Re: Request for Contested Case Hearing Regarding Application of Lower Colorado River Authority (LCRA) for Eight Operating and Transport Permits in Bastrop County, Texas (Well Nos. 58-55-5-0032; 58-55-5-0033; 58-55-4-0016; 58-55-4-0017; 58-55-4-0019; 58-55-4-0020; and 58-55-4-0021).

Evaluation of LCRA's Proposal to Pump 25,000 Acre-Feet per Year from the Simsboro Aquifer

George Rice
June 5, 2018

Figure 1
Geologic Units Represented in the GAM

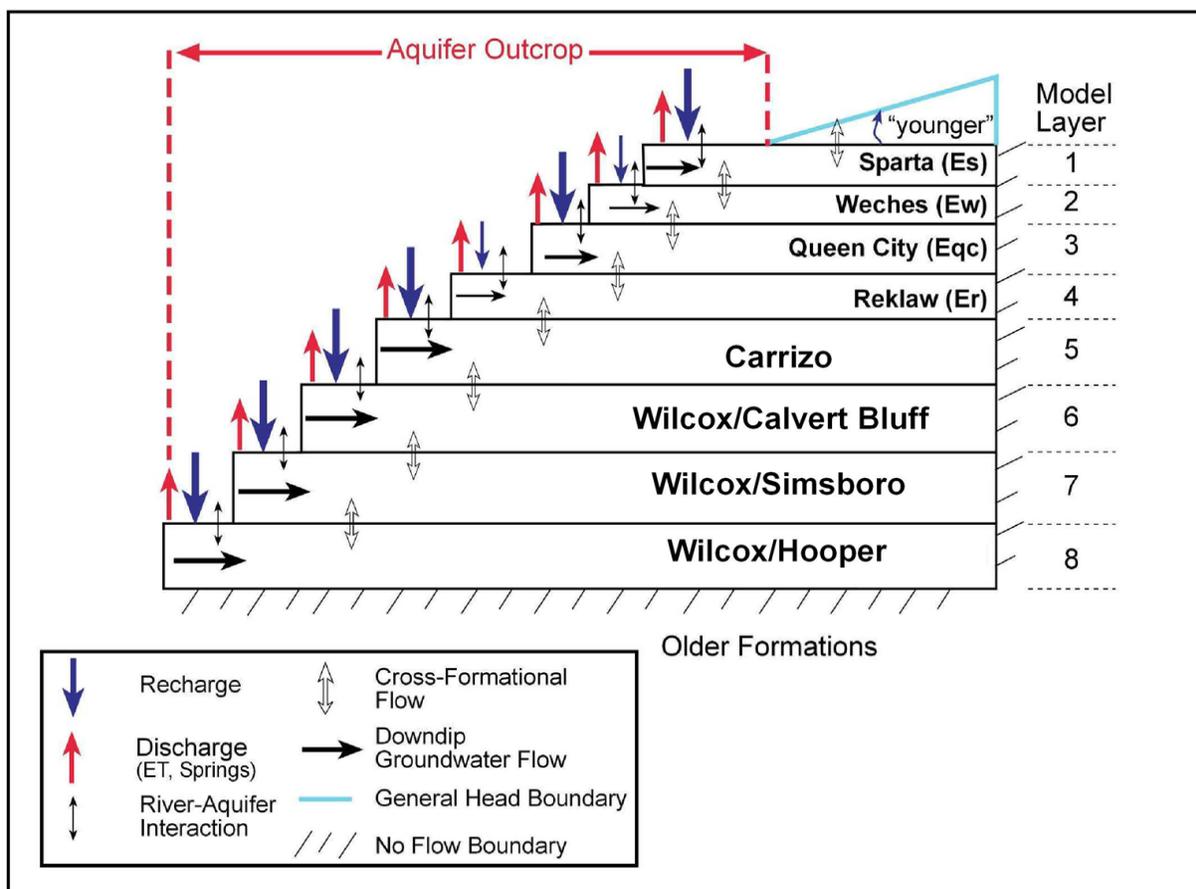
The effects of LCRA's pumping would not be limited to the Simsboro Aquifer. The pumping would induce leakage from the Calvert Bluff and Hooper aquifers. This leakage would reduce water levels in the Calvert Bluff and Hooper aquifers. In figure 1, leakage (cross-formational flow) between geologic units is indicated by double-headed arrows. In a 2009 pump-test conducted in Lee County, it was estimated that 22% of the water pumped from the Simsboro was derived from leakage from adjacent aquifers⁸.

Figure 2
Drawdown in Simsboro Aquifer Due to LCRA Proposed Pumping (2060)

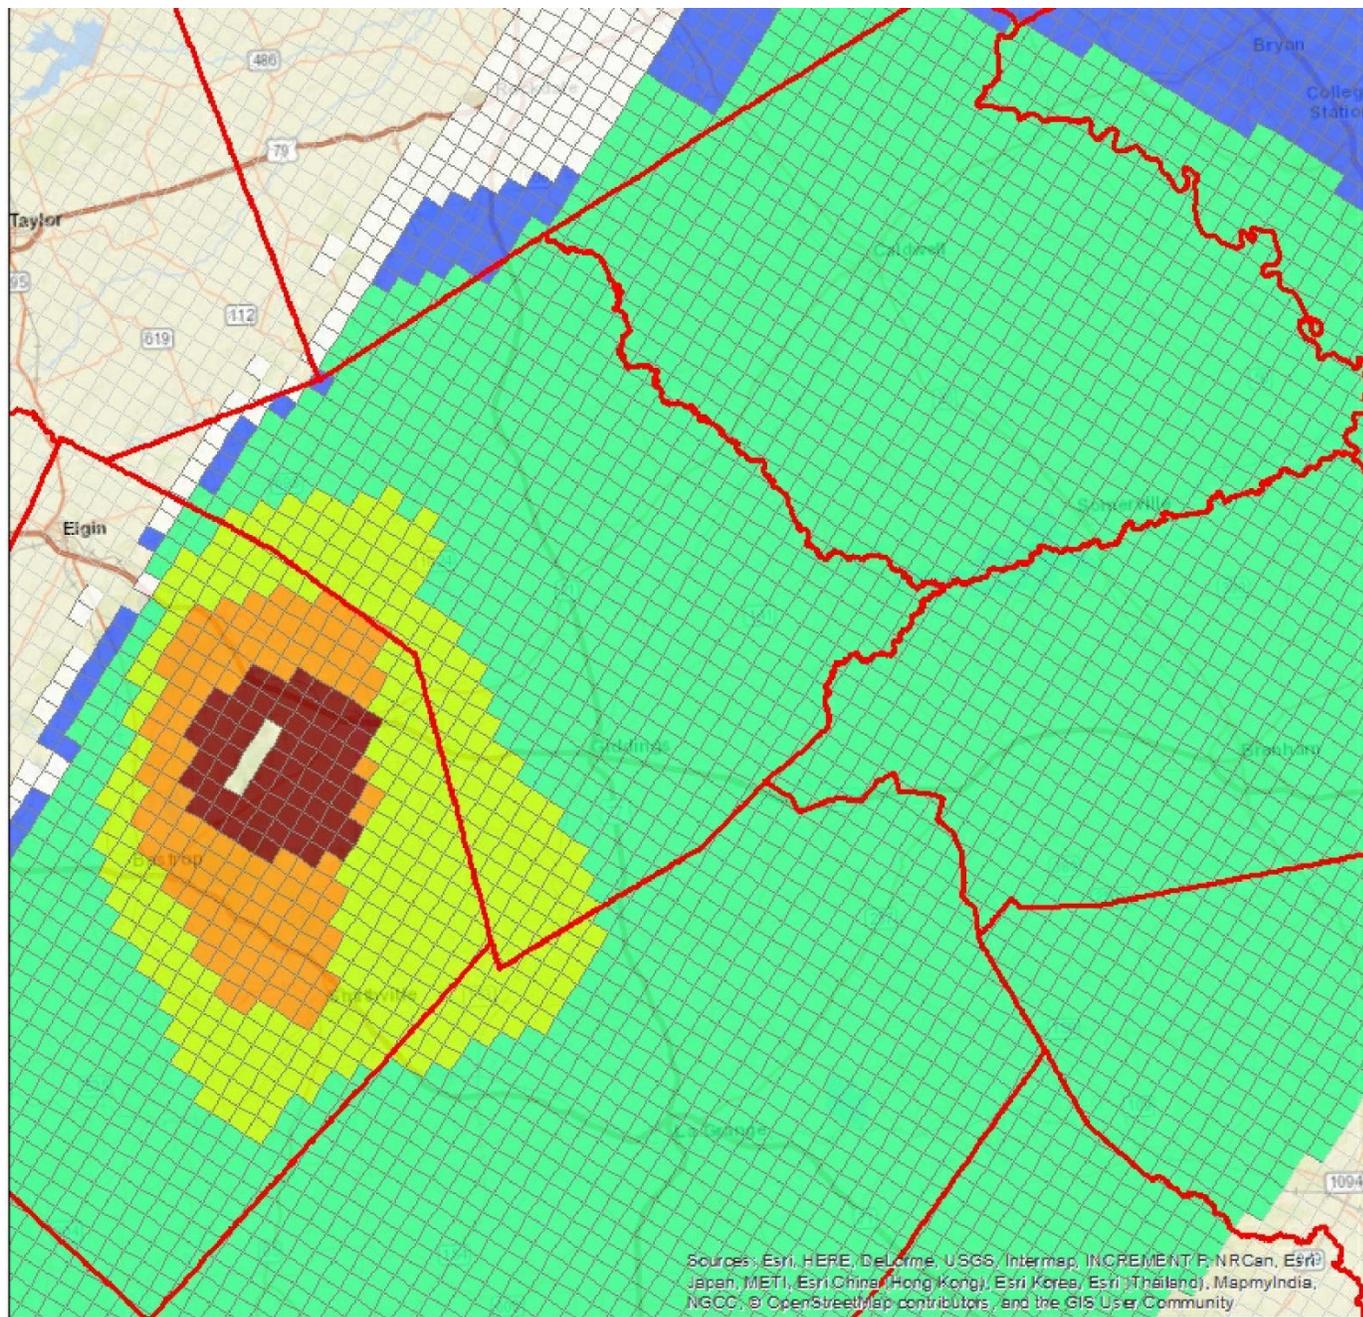
from beneath their property, and reduce the water level within their well. LCRA's modeling shows a drawdown at the Snider property of 250 feet to 300 feet in the Simsboro formation. Modeling by Mr. George Rice shows that the LCRA pumping will also result in drawdowns within the Calvert Bluff aquifer, including within the area where the Wunderlin well draws groundwater from that aquifer.¹ This drainage of water from beneath the Snider property, and drainage of water from the formations in which they own a well, will impact their use and enjoyment of their property and result in the impairment of their groundwater rights. Accordingly, Claire Snider Wunderlin and Michael Wunderlin would be adversely impacted by the proposed permits.

LCRA's pumping would reduce hydraulic heads in the Simsboro Aquifer. The effects would extend to both the confined and unconfined portions of the aquifer. Where the aquifer is confined, the reduction in heads will reduce water levels in wells that draw water from the aquifer. Where the aquifer is unconfined, the reduction in heads will dewater portions of the aquifer. Drawdowns in the Simsboro Aquifer due to LCRA's proposed pumping are shown in figure 2.

Figure 3
Drawdown in Calvert Bluff Aquifer Due to LCRA Proposed Pumping (2060)

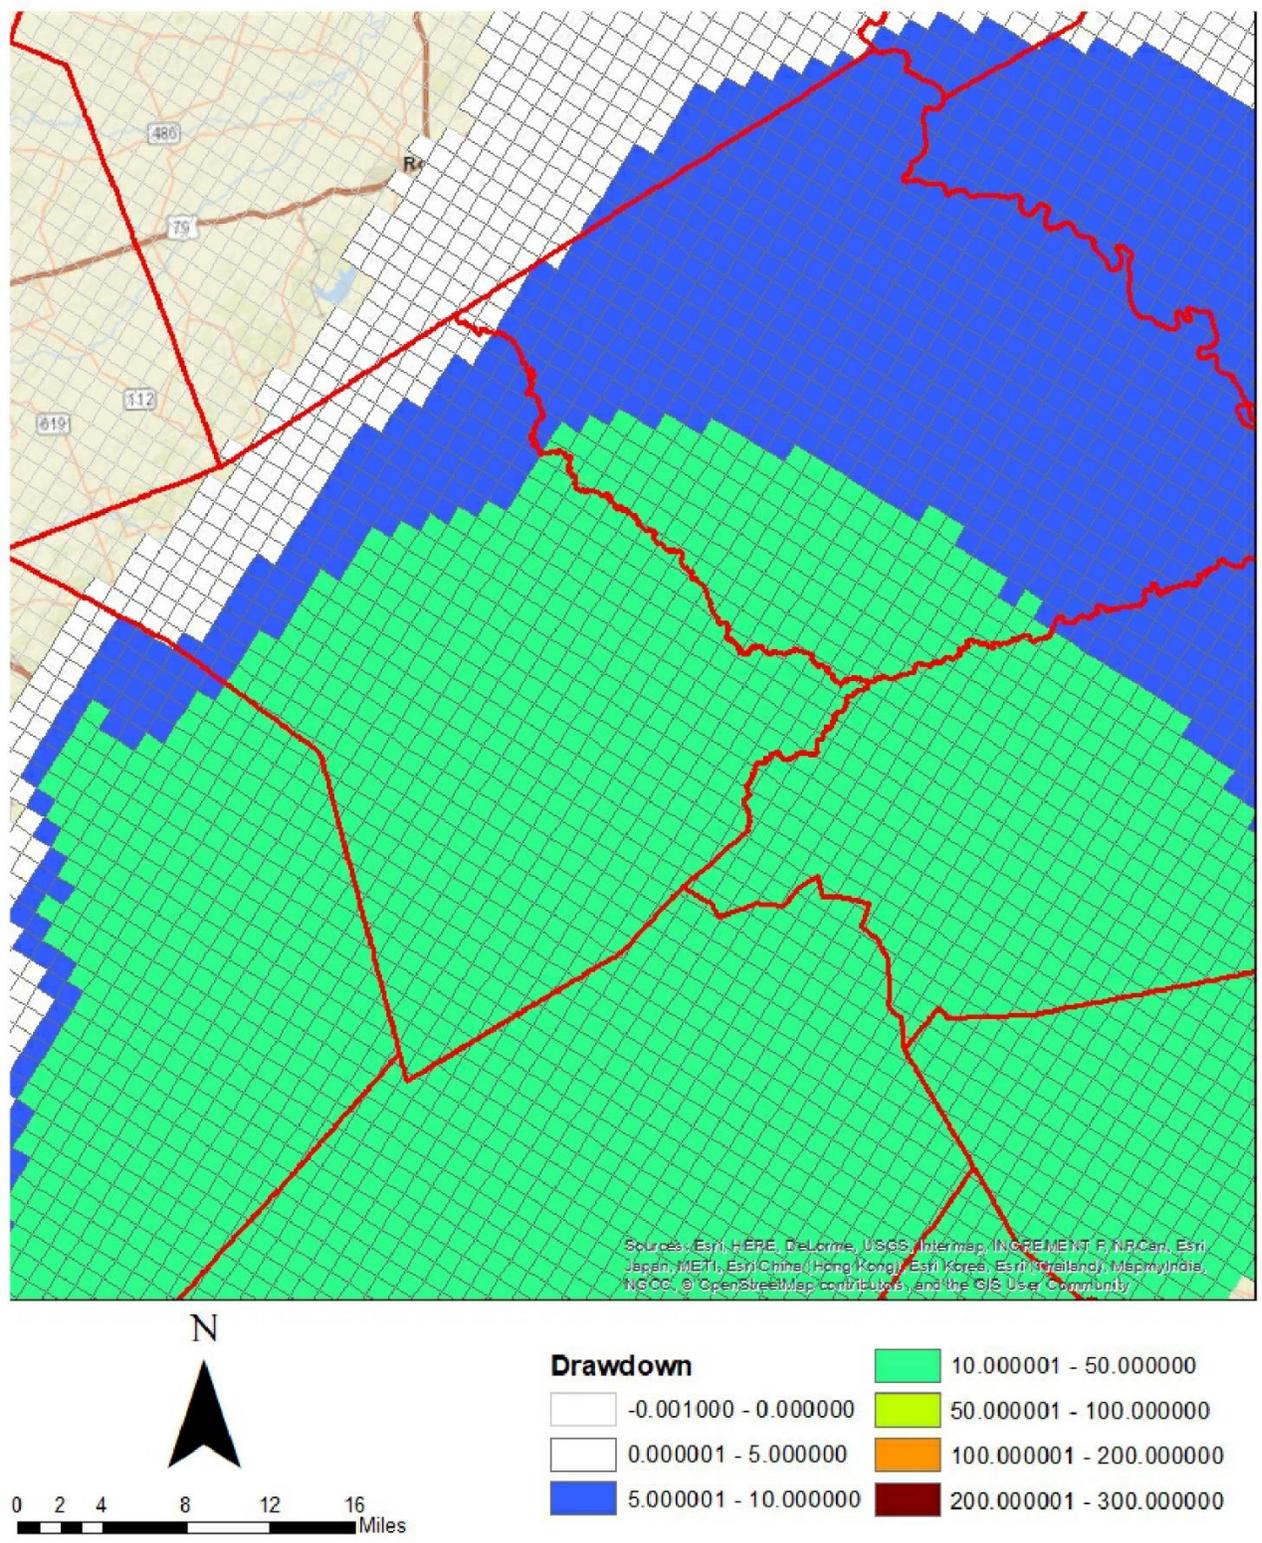
Table 1 shows the effects of LCRA's pumping on the Calvert Bluff, Simsboro, and Hooper aquifers. It should be noted that the drawdowns shown in table 1 would be in addition to the drawdowns due to baseline pumping (table 2). Drawdowns in the Calvert Bluff and Hooper aquifers due to LCRA's proposed pumping are shown in figures 3 and 4.

Figure 5
GAM Prediction of Groundwater Discharge to Colorado River and its Tributaries

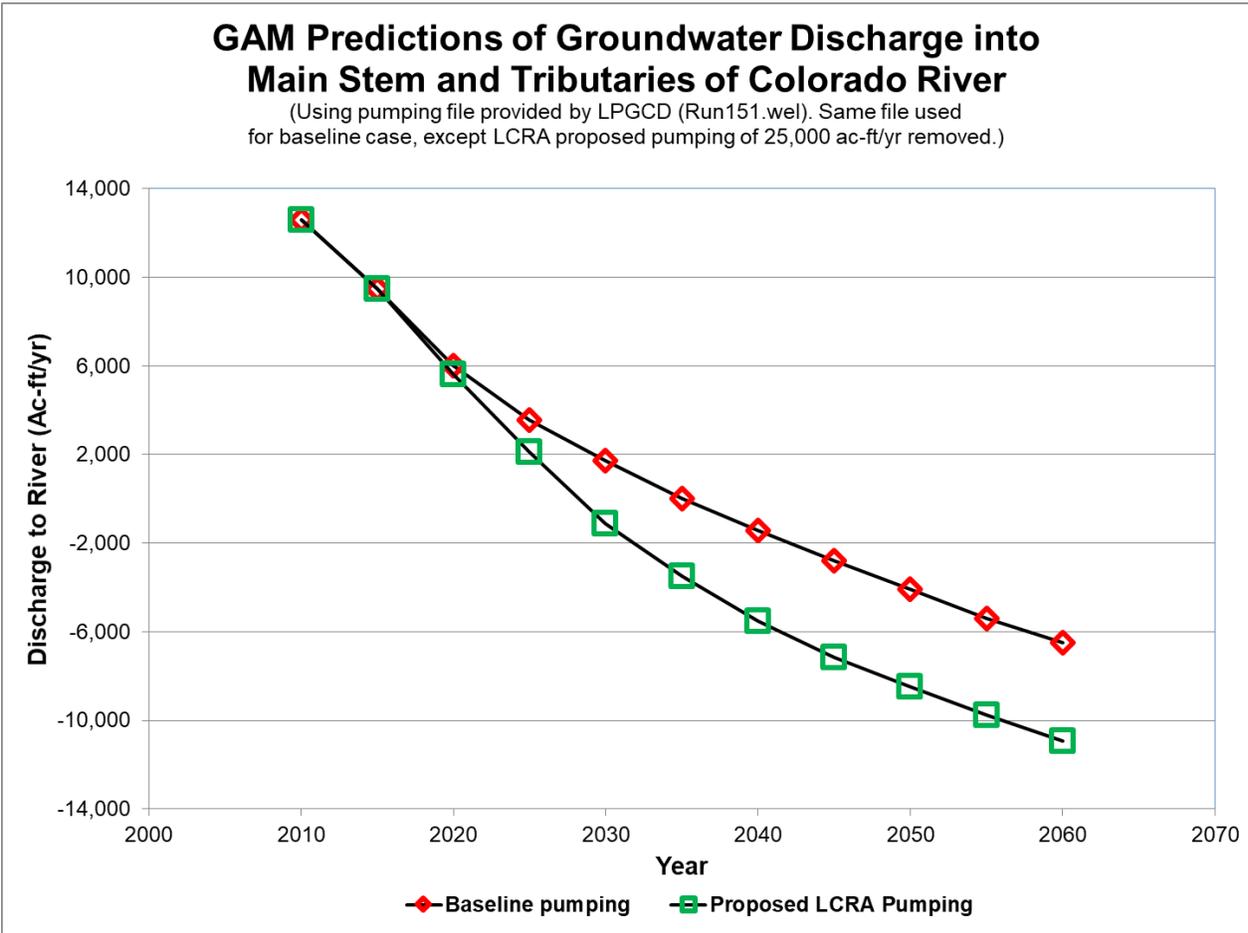
As shown elsewhere, the GAM does not accurately predict the effects of pumping on the amount of groundwater discharged to the Colorado River. It does, however, reliably predict the trends in groundwater discharge resulting from pumping.¹¹ A new version of the GAM is being developed¹². One objective of the new GAM is *to help improve the capability to simulate surface water-groundwater interaction ...*¹³

Figure 5 shows that LCRA’s pumping would decrease groundwater discharge to the Colorado River.
